Fiat Scudo - Potência insuficiente do ar condicionado | HELLA

Scudo 1,6D Multijet 90

Ano de fabrico: de 2007 até VIN 84160387

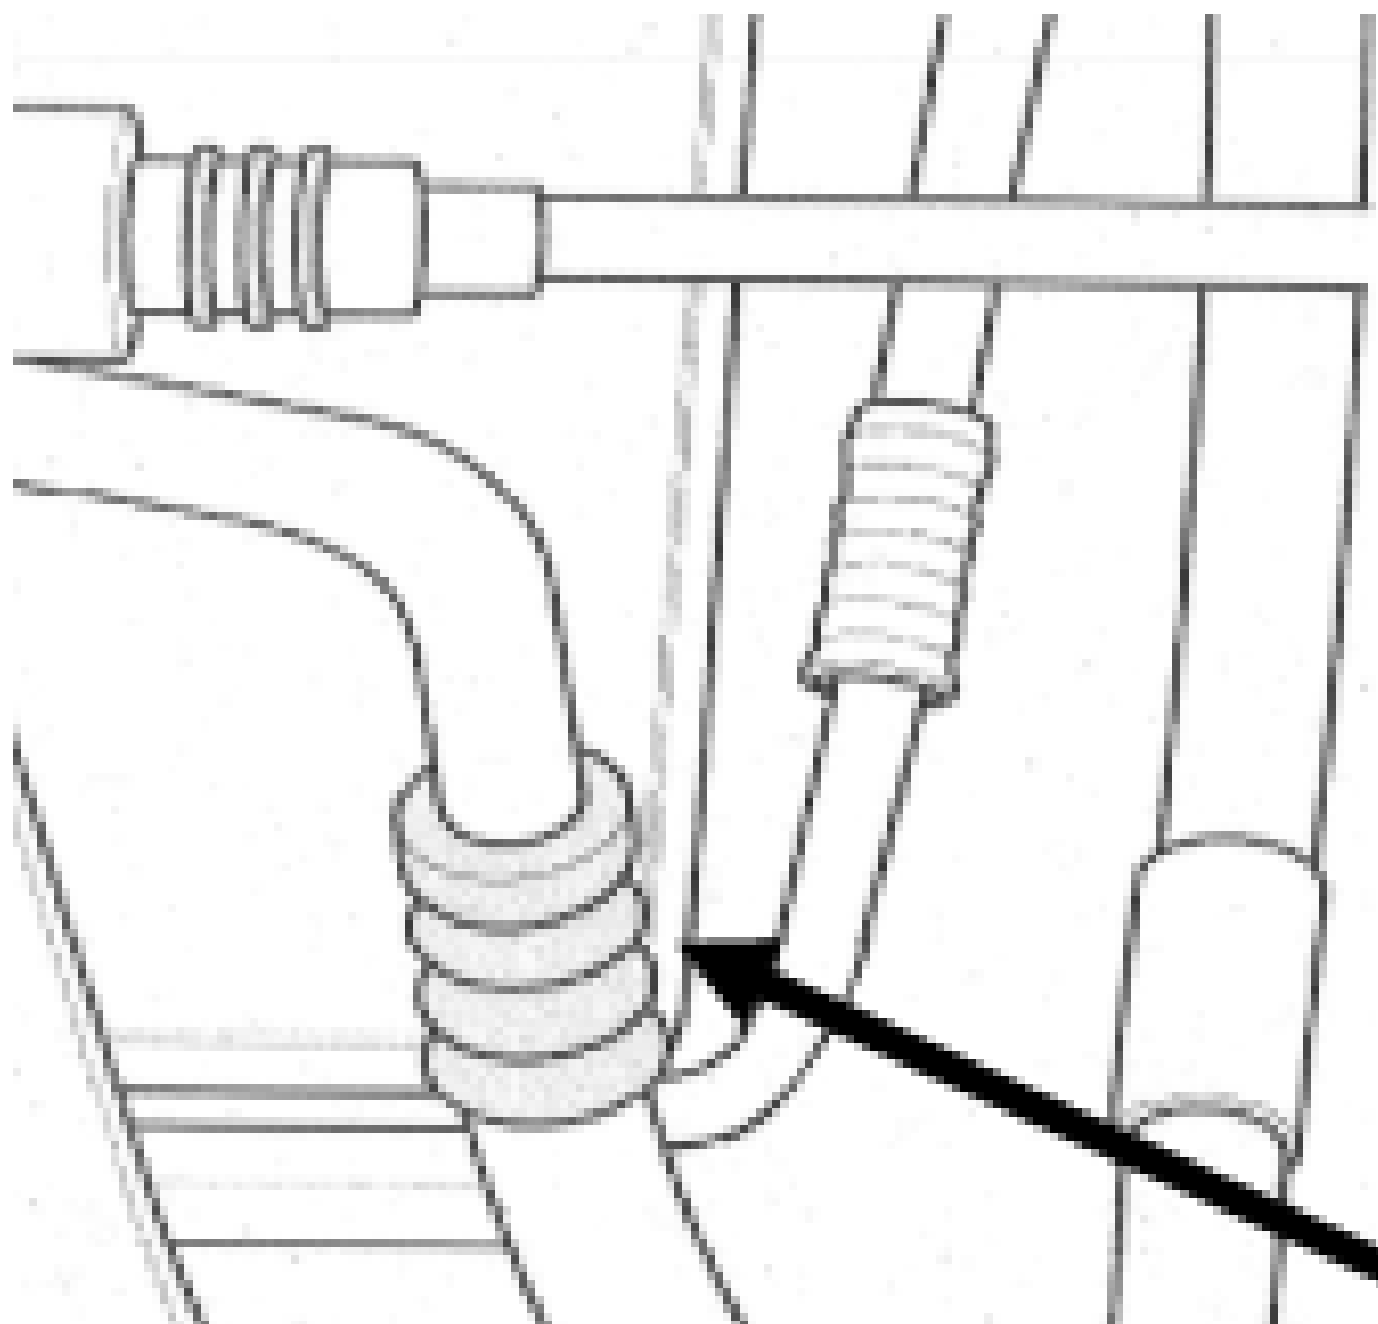
Se nos veículos supracitados for detetada uma potência insuficiente do ar condicionado ou uma perda do líquido refrigerante, uma possível causa pode ser uma fuga na tubagem do líquido refrigerante entre o condensador e o compressor.

Verificar se a conexão do líquido refrigerante é do tipo correto e eventualmente substituir. (Ver figuras)

Tipo antigo

-Novo tipo -

O fabricante automóvel dispõe de um tipo modificado: [Peças Sobressalentes (PS)]

- 1 unidade: tubagem do líquido refrigerante :(PS):. 140142280

2 unidades: O-Ring: (PS):. 9645950980
